UNITED STATES PATENT AND TRADEMARK OFFICE

Office Action Summary	Application No. 10/587,680	Applicant(s) ELLNOR, PIET	
	Examiner JOSHUA J. MICHENER	Art Unit 3644

DETAILED ACTION

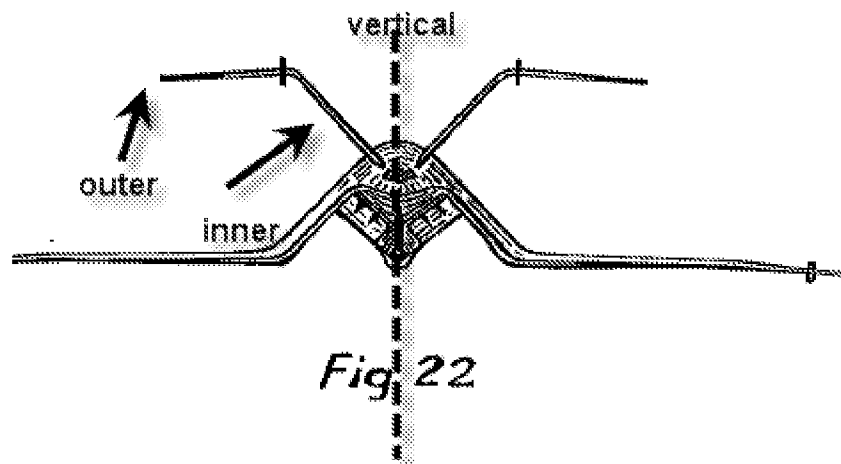
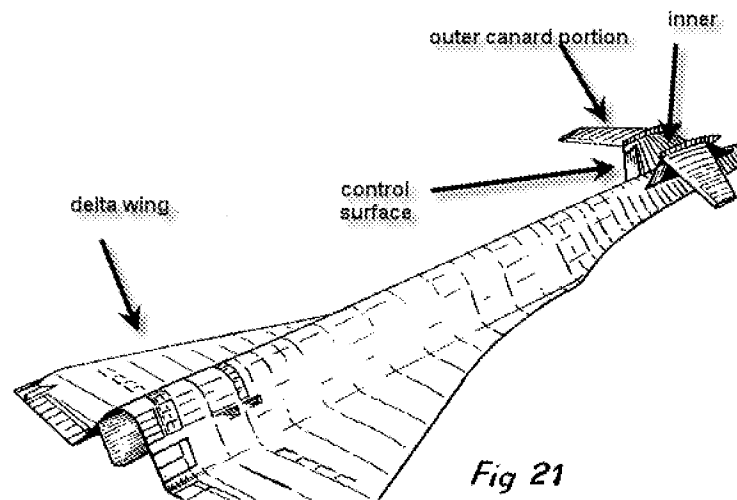
13. Regarding claim 1, as best understood, Fraser discloses a canard forewing (fig 21 below) and a main wing (delta wing), wherein the canard forewing has a substantial portion (inner portion) with a dihedral configuration. It is noted, an aircraft flying near the ground creates a

14. Re claim 7, the canard forewing has said a dihedral configuration in its inner portion, said inner portion being disposed at a first angle of inclination from the vertical (fig 22 above), said canard forewing having its outer portions disposed at a second angle of inclination from the vertical (fig 22 above) which is greater (i.e. about 90) in absolute terms than said first angle (i.e. about 45 – 70 degrees). It is noted, these relative angle approximations are considered to be

15. Re claim 20, said canard forewing incorporates control surfaces (fig 21 above).

16. Re claim 21, said main wing is of forward delta configuration (fig 21 above).

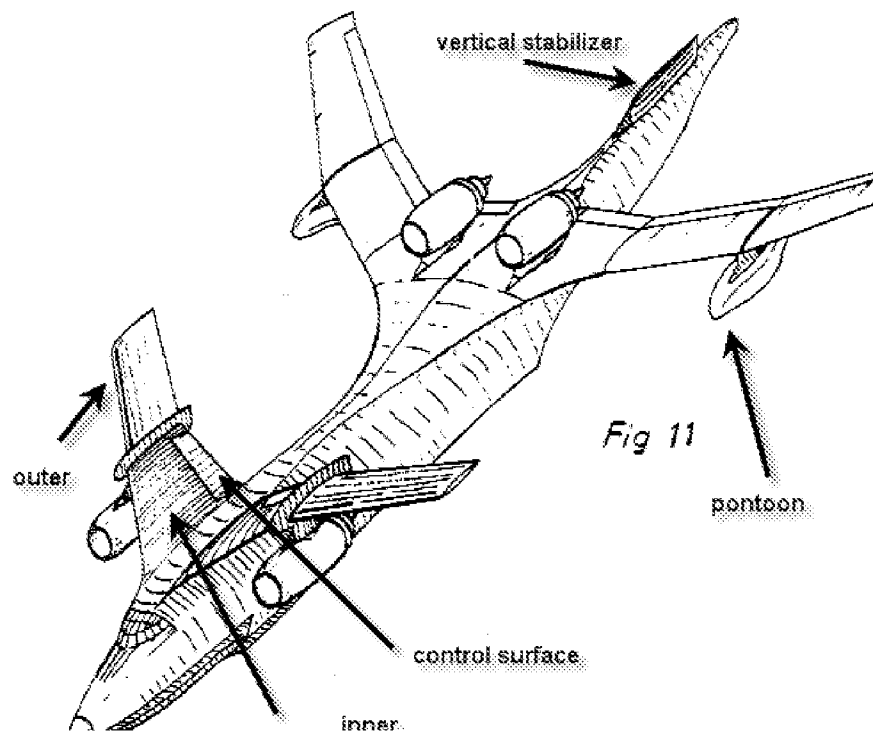
17. Regarding claim 1, as best understood, Fraser discloses a canard forewing (fig 11 below) and a main wing (fig 11), wherein the canard forewing has a substantial portion with a dihedral configuration (fig 11, col 6, line 63).

18. Re claim 20, said canard forewing incorporates control surfaces (fig 11 above).
19. Re claim 25, said wing-in-ground-effect craft is amphibious (col 6, line 58 – col 7, line 10), and has a planing hull (col 6, line 67).
20. Re claim 27, said craft has a single vertical stabilizer (see fig 11 above) located at the rear thereof.

30. Re claim 26, Fraser discloses a main wing that incorporates pontoons (see fig 11 above), but fails to teach the pontoons are located at the outer most extremity of the main wing.
